Ipswich City Council

28 September 2023

Re: Minor Alteration to Development Approval – Staging Amendments and Built to Boundary Changes
Application No: 1546/2020/PDA
Proposal: Reconfiguring a Lot (Three (3) Lots into Four Hundred Thirty Nine (439) Residential Lots and Park) with a Plan of Development Material Change of Use - Residential, Sales Office and Display Home
Property Location: 160-186 Daleys Road, RIPLEY QLD 4306, 188-208 Daleys Road, RIPLEY QLD 4306, 210-224 Daleys Road, RIPLEY QLD 4306

LEVEL DATUM		N/A	
LEVEL ORIGIN		N/A	
CONTOUR INTERVAL		N/A	
COMPUTER FILE		BRSS5365-ORC-6-19	
DRAWN	TKW	DATE	19/09/2023
CHECKED	TKW	DATE	19/09/2023
APPROVED	SRS	DATE	19/09/2023
UDN		SHEET 2 OF 9	
BRSS5365-ORC-7-18

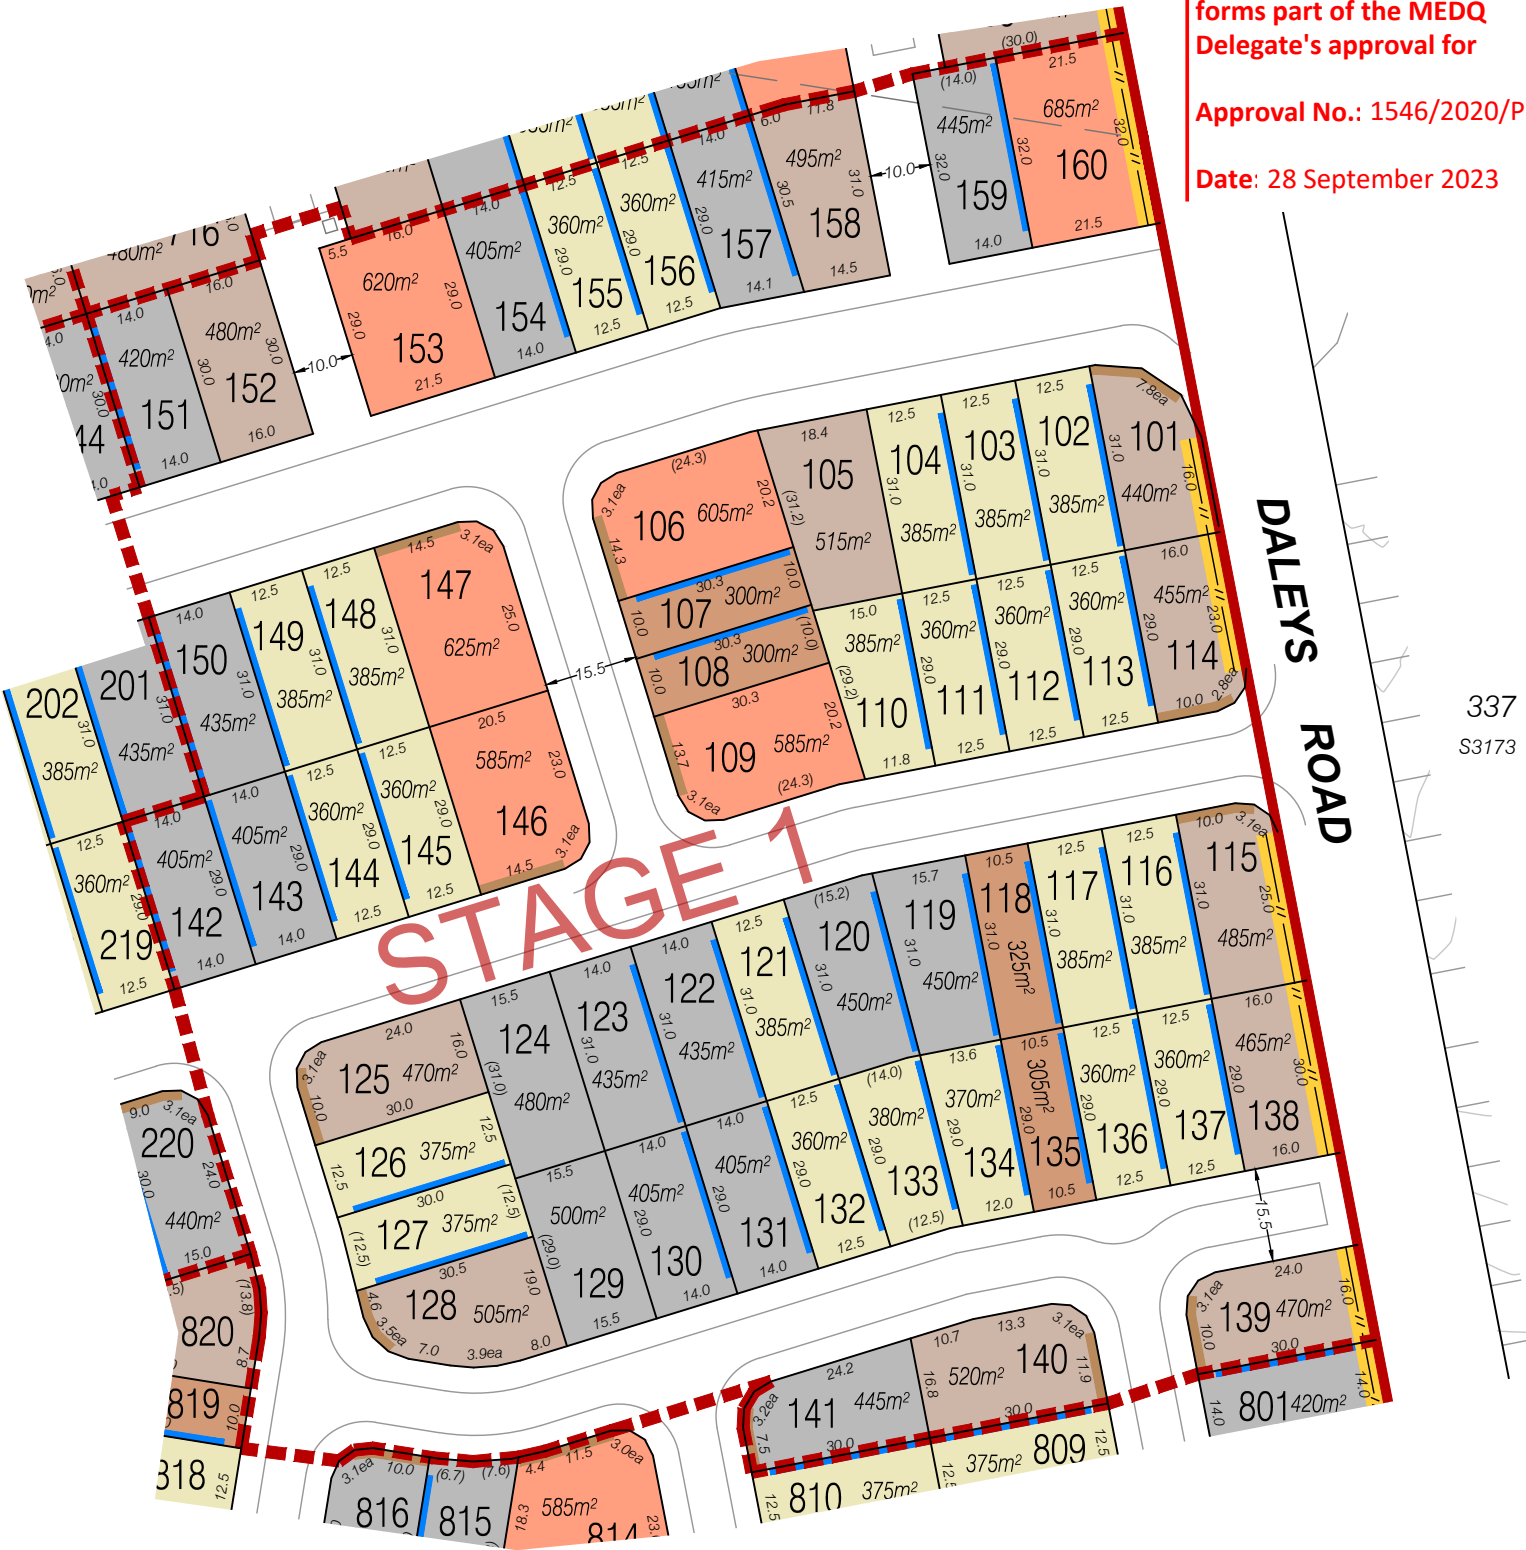
- Amend the staging of the development to:
 - Approved Stage 6 change to Stage 7;
 - Approved Stage 7 changed to Stage 8;
 - Approved Stage 8 changed to Stage 6.
- As a result of the above changes, it is noted that a change to Condition 11 – ‘Parkland and Road Buffer Dedication’ is required to reflect the correct plan reference.
- Amend the location of the built to boundary wall of lot 819 due to the location of services and as a result the built to boundary wall for lot 818 has been removed.

1.	<i>Proposed Reconfiguration Plan</i>	<i>BRSS5365-ORC-8-14 16</i>	26 October 2022 <i>19 September 2023</i>
2.	<i>Plan of Development Sheets 1-9</i>	<i>BRSS5365-ORC-7-16 18</i>	26 October 2022 <i>19 September 2023</i>
